E3632A-04C**S E R V I C E N O T E**Supersedes:
E3632A-04B**E3632A DC Power Supply****Serial Numbers: MY51250037 to MY53220020****Metal Strap Kit for tightening loose bumper and for fitting rear lock link in side-by-side rack mounting****Parts Required:**

July 9, 2013

Figure 2: Top view 3mm gap observed on rear lock link for side-by-side rack mounting

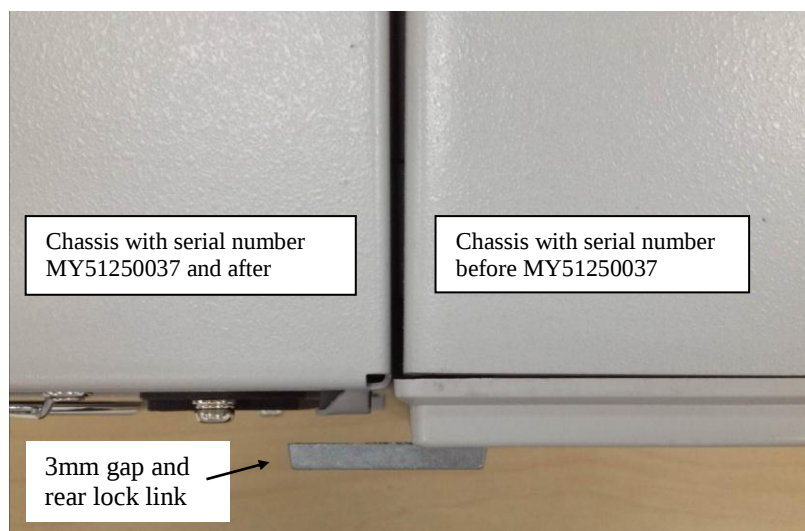
The 3 mm gap between the two different chassis may cause difficulties in securing them together using a rear lock link kit (part number 0050-2167) for side-by-side rack mounting as shown in Figure 2 below.

Solution for Situation 2

Use metal strap (part number E3631-07901), and stack the provided two metal straps together to form 3mm thickness and secure it with the provided screws on the rear lock link as shown in Figure 4 below.
